NOTICE OF THE MEETING OF THE PLAN COMMISSION

AGENDA FOR REGULAR MEETING VILLAGE OF TINLEY PARK PLAN COMMISSION

**ITEM #1 WORKSHOP – BETTINARDI EXPANSION, 7650 GRAPHICS DRIVE – SITE
PLAN APPROVAL AND SPECIAL USE FOR A SUBSTANTIAL DEVIATION
FROM A PLANNED UNIT DEVELOPMENT**

**ITEM #2 PUBLIC HEARING – DURBIN’S EXPRESS, 18250 OAK PARK AVENUE – SITE
PLAN APPROVAL, SPECIAL USE FOR A RESTAURANT PICKUP WINDOW,
AND VARIATION**

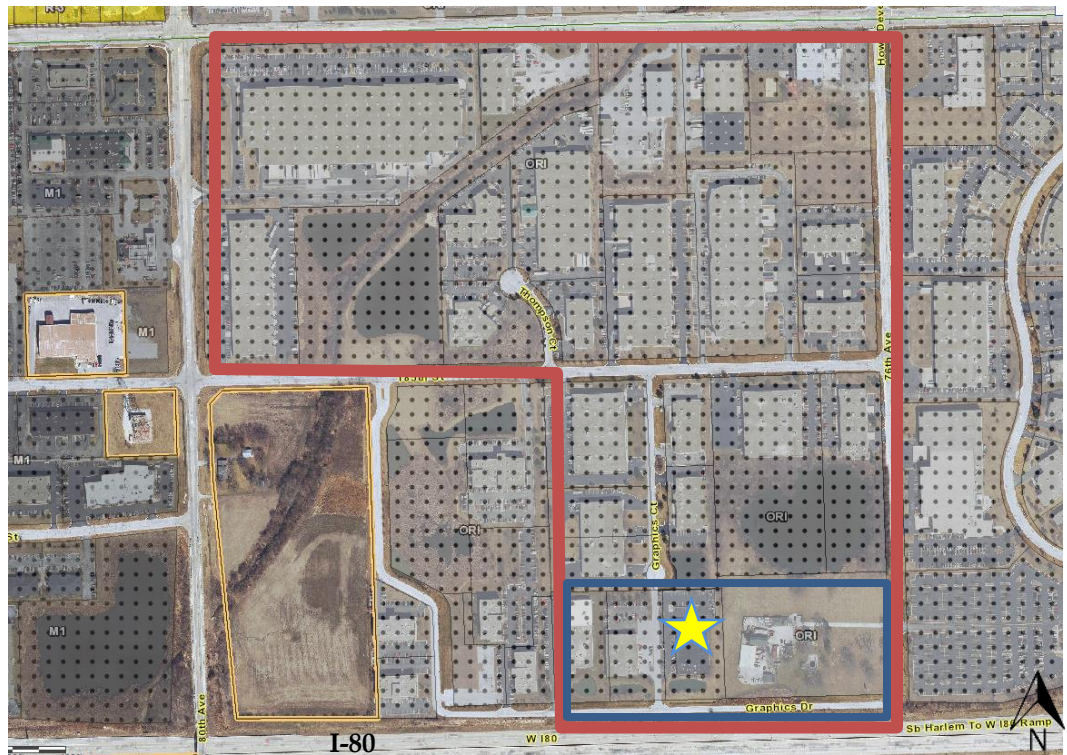
Open Item #1: Review the location of the building addition and overall site plan layout.

The new parking stalls are located in the front yard which is not permitted, except for single-family residences (who can park on driveways in the front yard). That parking location in the front yard requires an exception to the code. The Petitioner has proposed this location because it is the best location to add some visitor parking near to the main entrance, and separate from employee parking. Additionally, there are other sites in the area, including the existing Bettinardi site on lot over, that have front yard parking (see image below). If the Plan Commission wishes to recommend approval of the Exception, staff recommends the Petitioner explore installing a walkway to the front door to avoid visitors walking in the main drive aisle.

Open Item #7: Discuss proposed lighting and staff's recommendation for existing fixtures to be replaced to match the proposed addition's fixtures. A revised Photometric Plan shall be submitted indicating adequate lighting for the new visitor parking stalls.
